RE: Sage & 86th St Gymnasium

Conceptual Grading & Drainage Plan Engineer's Stamp Date: 12/06/22 Hydrology File: M09D033

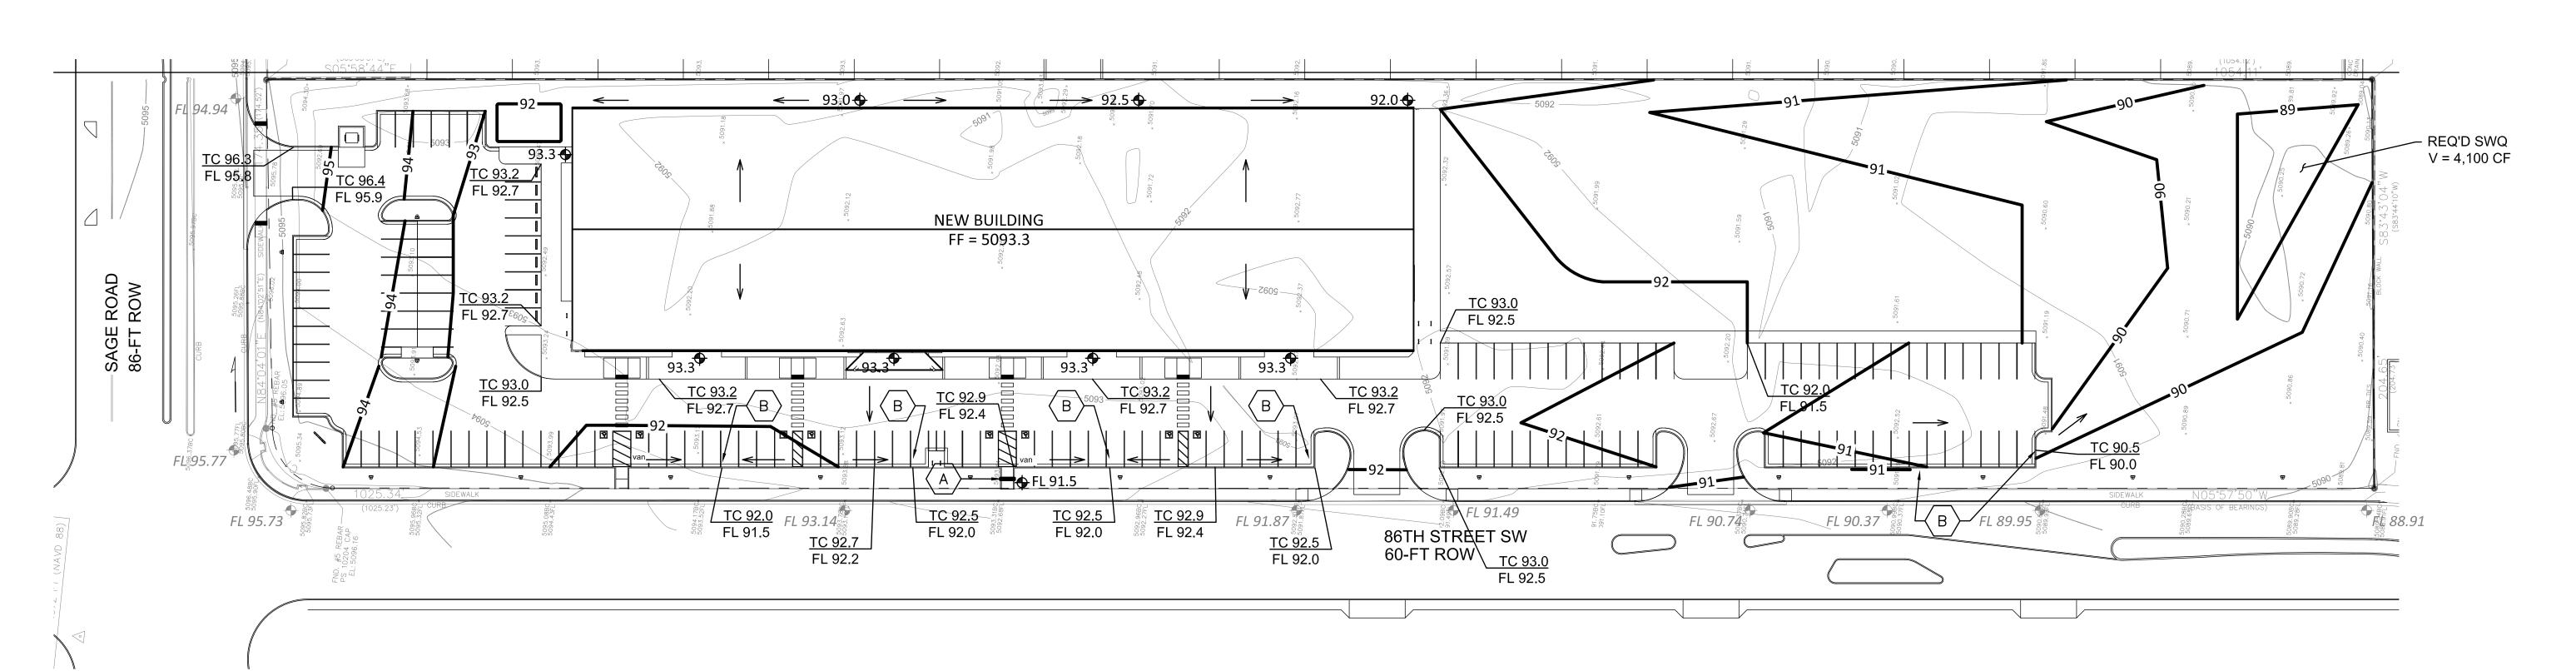
a. A waterblock, per COA Paving Detail No. 2426, is required at the driveway entrances. There currently is not any waterblocks and most of the drainage within the parking areas are just draining to the streets. The waterblocks are needed to direct the drainage to the SWQ ponds.

- b. Each SWQ ponds need to be labeled with the provided volume, top of pond and the bottom of pond elevations, and some sort of spillway (sidewalk culvert, pipe to the back of curb, or curb cut). To accommodate the spillways such as sidewalk culverts, please place the SWQ pond closer to the property lines/streets.
- c. Provide curb cuts within the parking lot to allow drainage to get to the SWQ ponds.
